BID 22-007
CLARK AVENUE FENCING REPLACEMENT PROJECT

ADDENDUM NO. 1

April 5, 2022

DWG #: CL10

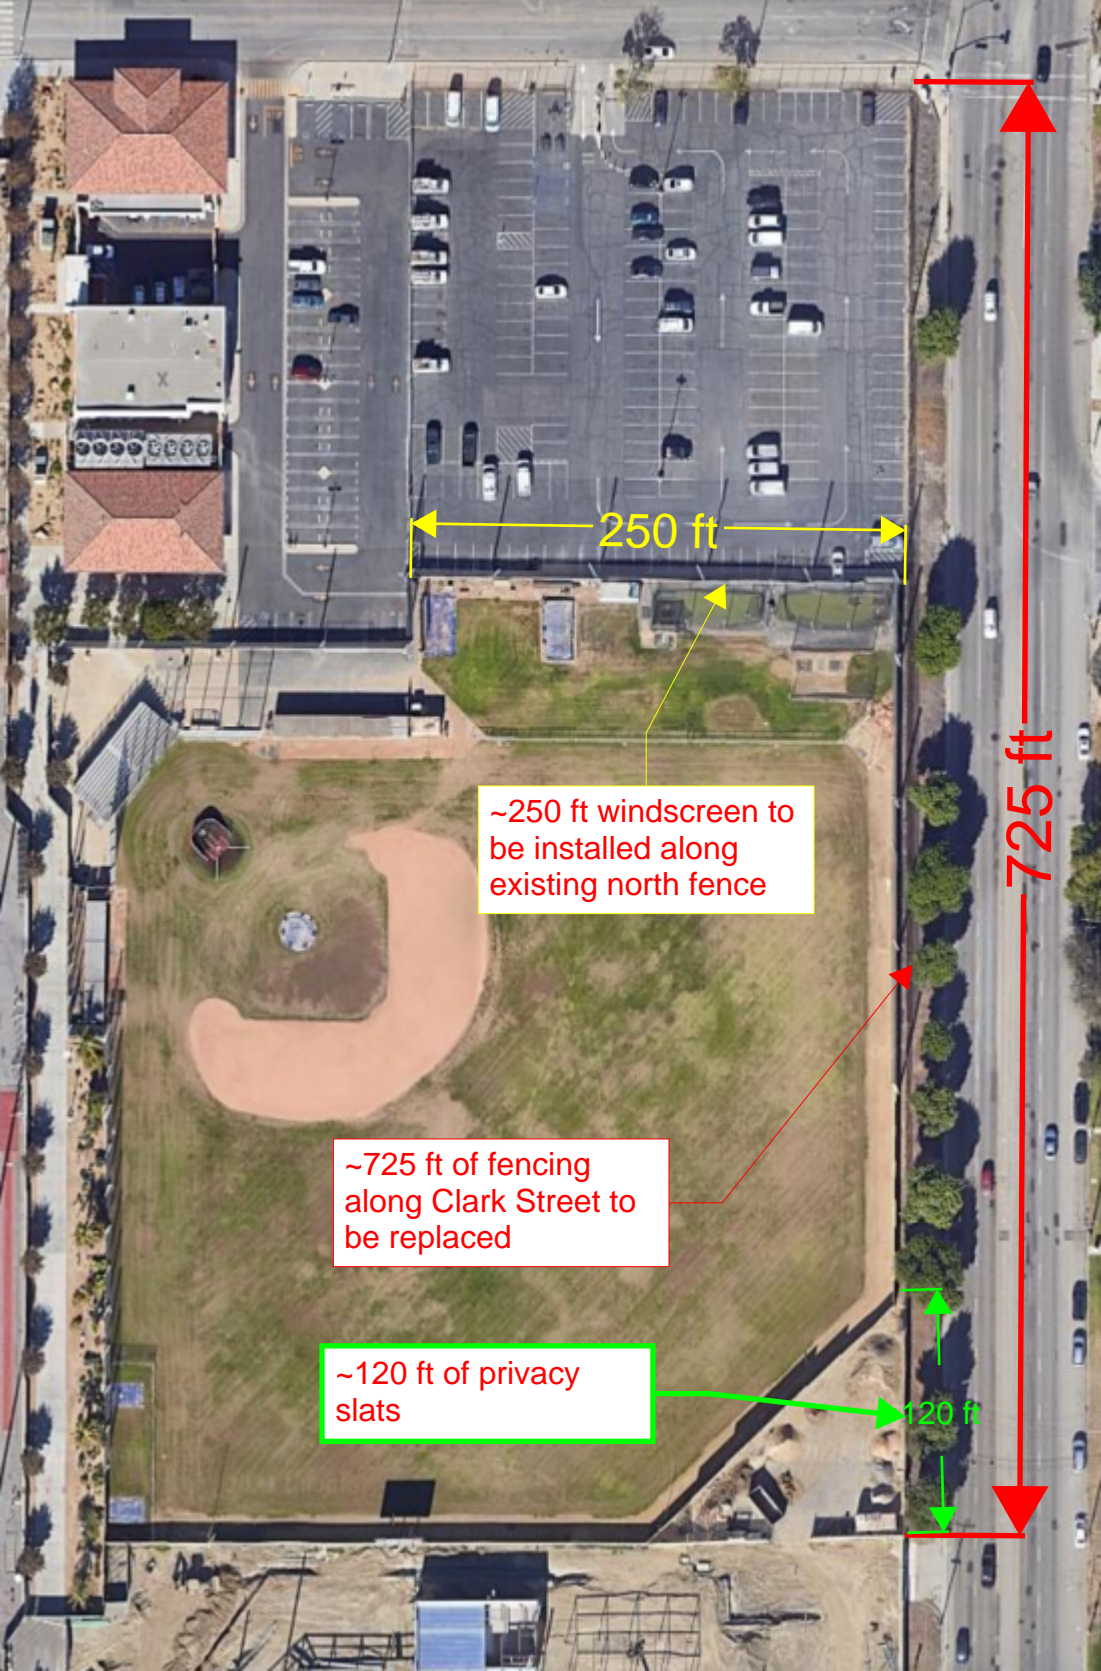
3. Please see attached document with drawings and photos.
